Onondaga County Planning Board

MEETING AGENDA

Wednesday, August 5, 2026
11:00 AM

ONONDAGA COUNTY PLANNING BOARD STAFF REPORT AUGUST 05 2026 S-26-24

S-26-24

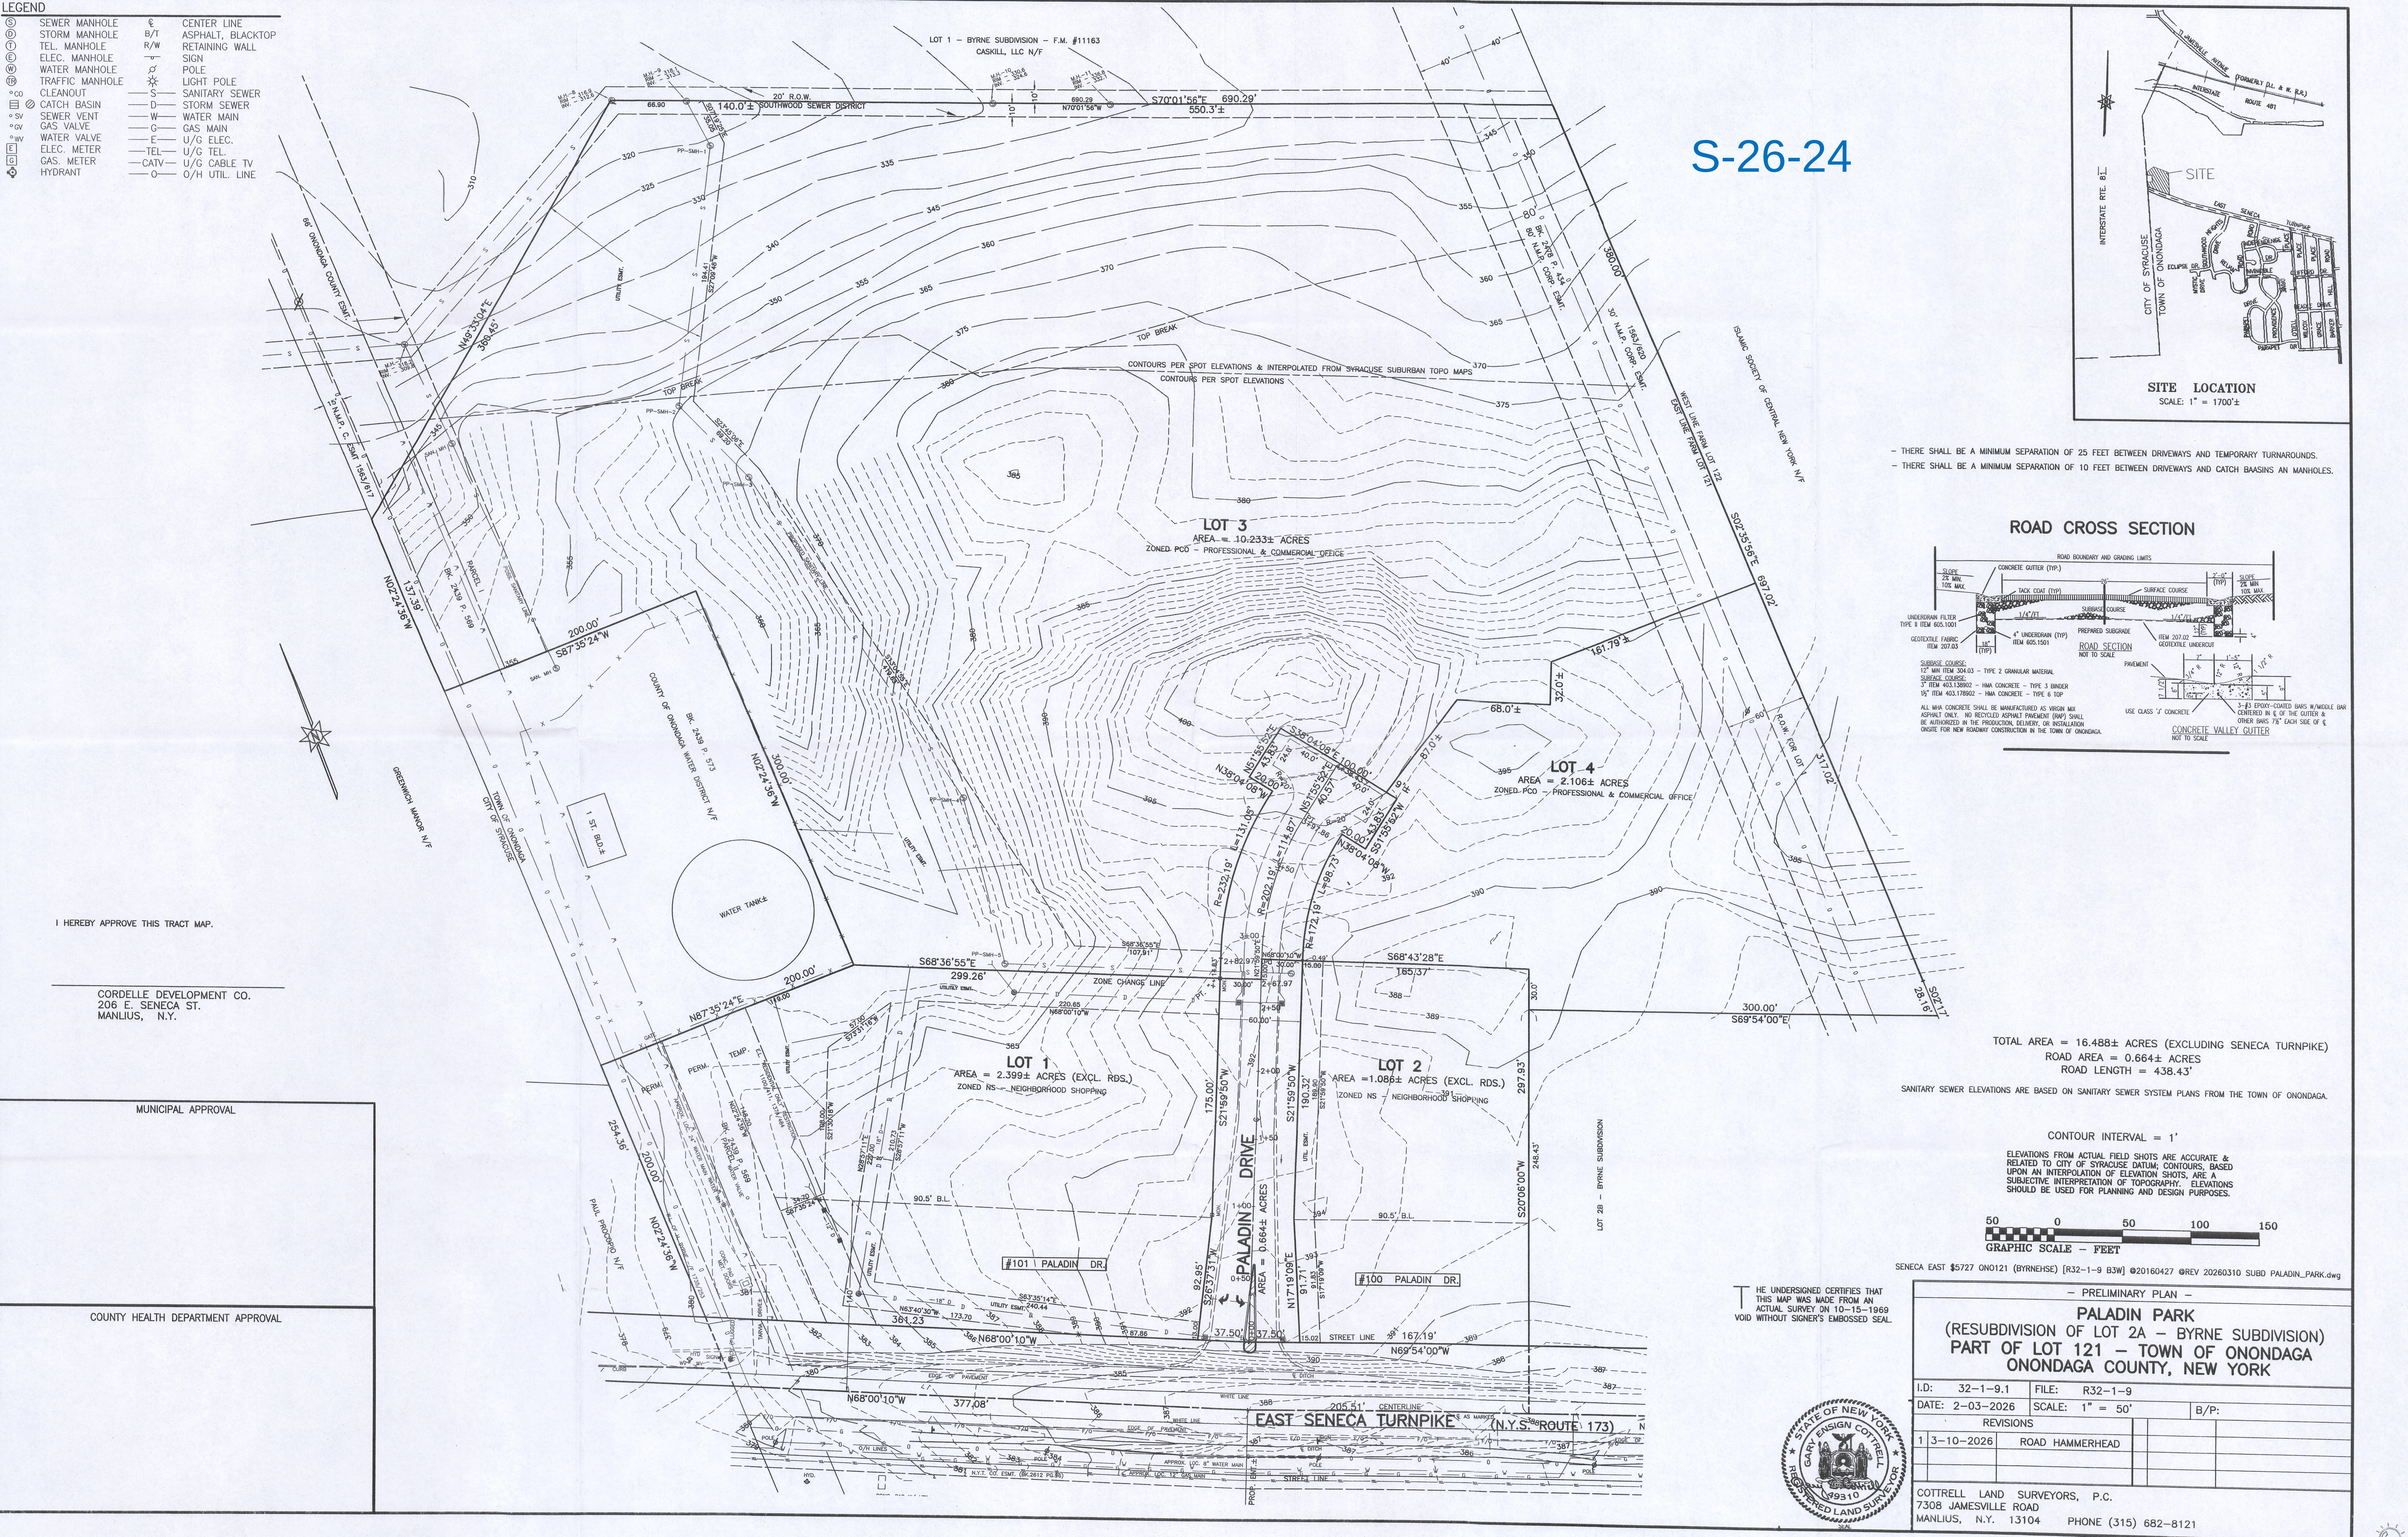
Project Detail:	Per the referral notice, the applicant is proposing to divide the site into four new lots and “office space planned for Lot 4 and apartments on rear lots.” There is no discussion in the Environmental Assessment Form (EAF) dated 2/4/26, regarding the future development of the site. Location of apartments or office uses are not detailed.
Access:	Per the Subdivision Map, a new access road, Paladin Drive, is proposed to provide East Seneca Turnpike access to all four lots. Paladin Drive will be located between proposed Lots 1 and 2 and will terminate in a hammerhead between proposed Lots 3 and 4. It is unclear whether Paladin Drive will be a public or private road. ADVISORY NOTE: Per the NYS Department of Transportation, all existing or proposed driveways on East Seneca Turnpike must meet Department requirements.
Easements:	Per the Subdivision Map, multiple easements are located on site: · An 80'-wide Niagara Mohawk Power Corporation easement is located along the eastern side boundary. · A 20'-wide Utility Easement crosses proposed Lot 1. · A 5'-wide Utility Easement is located along the western boundary of proposed Lot 2. · A 66'-wide County Water easement is located along the western parcel boundary. ADVISORY NOTE: OCWA's Engineering Department requires the applicant to contact them to determine the activities and structures permitted within OCWA easements/rights-of-way, water availability and service options, obtain hydrant flow test information, evaluate backflow prevention requirements, and/or request that the Authority conduct hydrant flow testing to assess fire flow availability.

Floodplain/Flood way:	Current FEMA Flood Insurance Rate Maps (FIRM) indicate that the rear boundary of the site is located within the 100-year floodplain, which may require avoidance or elevation of structures and other mitigation. ADVISORY NOTE: The Onondaga County Hazard Mitigation Plan has identified flooding as a natural hazard of local concern, with the potential to cause extensive threat to property and safety. Buildings within the floodplain can negatively affect the

Plants/Animals: The site may contain the Indiana bat and/or Northern long-eared bat, or their associated habitats, which have been listed by the state or federal government as threatened or endangered animal species (per EAF Mapper). Impacts to bat species are often associated with tree clearing and from aerial imagery it appears that some significant wooded areas on site will be removed.

LIMESTONE – NORTON
SUBDIVISION

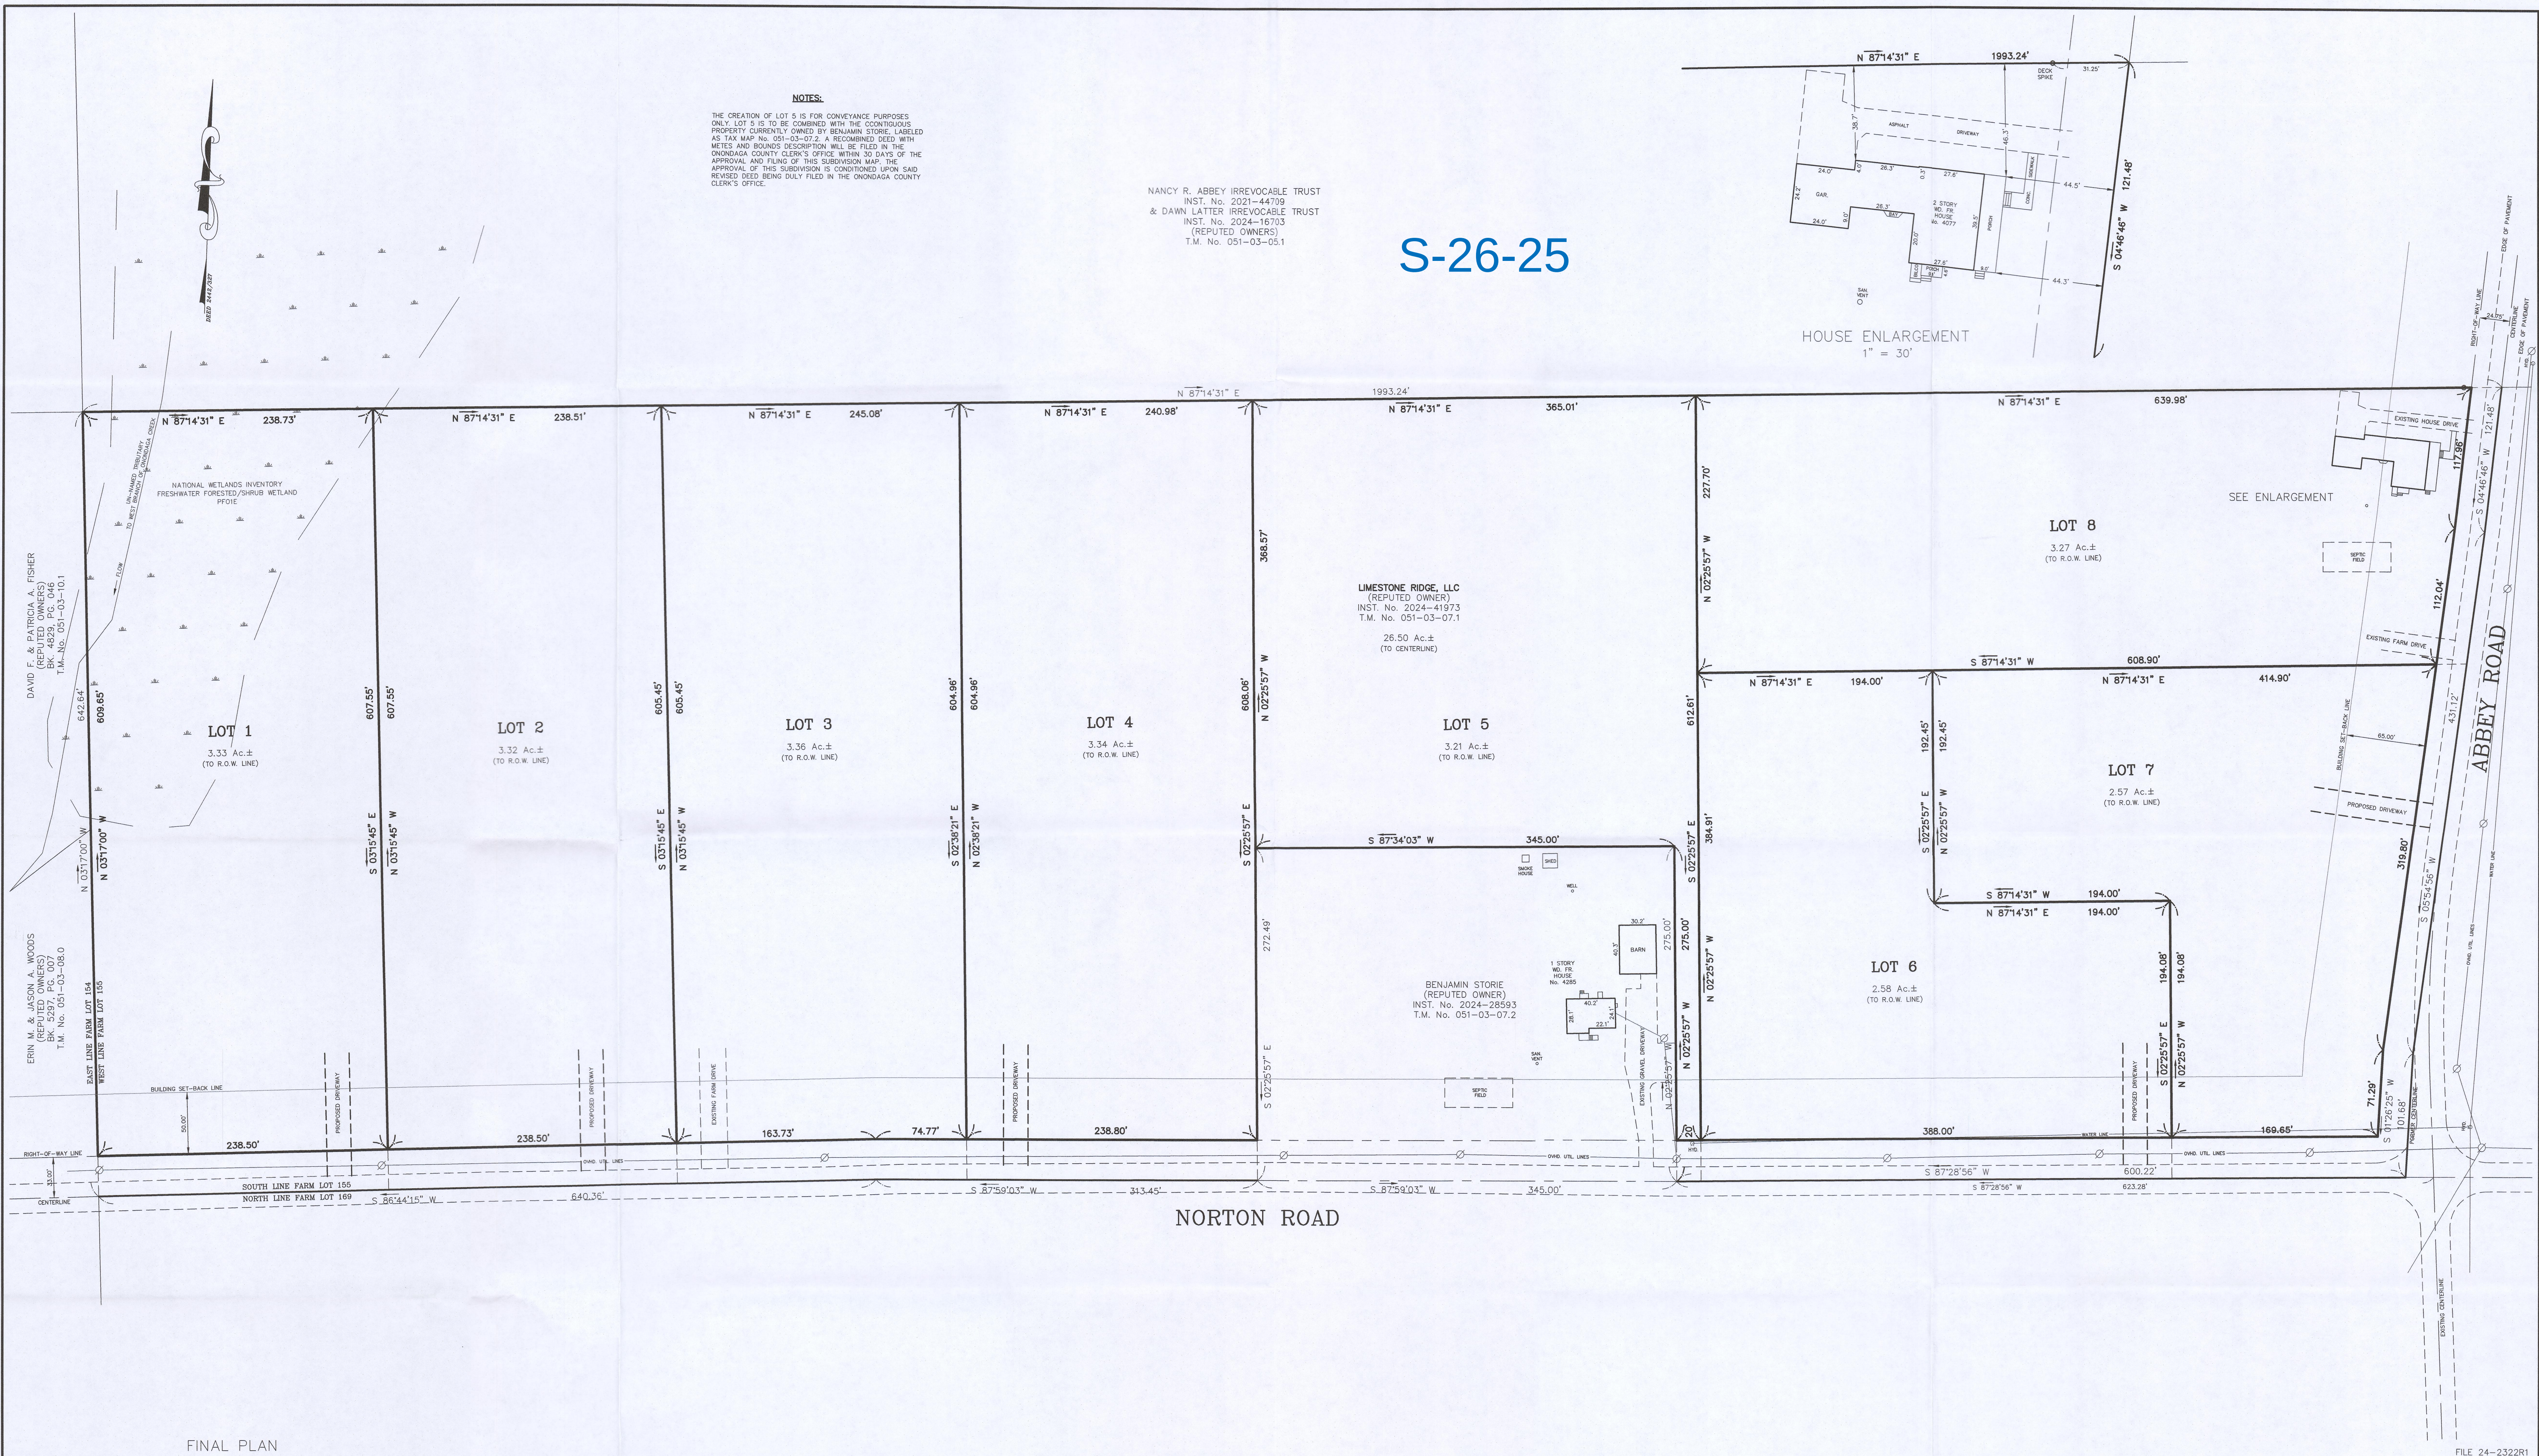
Access:	Each of the proposed lots (except Lot 5) show existing or proposed driveways to either Norton Road or Abbey Road, both county roads. ADVISORY NOTE: Per the Onondaga County Department of Transportation, all existing or proposed driveways on Norton or Abbey Roads must meet Department requirements, including sight distance.
Drinking Water:	OCWA drinking water occurs on Norton Road. The applicant is proposing new connections to public drinking water to serve the proposed lots. ADVISORY NOTE: OCWA's Engineering Department requires the applicant to contact them to determine water availability and service options.
Wastewater:	The site is located outside of the Onondaga County Sanitary District. The applicant is proposing individual septic systems to serve the propose lots. ADVISORY NOTE: New York State and Onondaga County laws require the design of sewage disposal and water supply provisions to serve this property to be approved by Onondaga County Health Department's Bureau of Public Health Engineering prior to Department endorsement of the subdivision.
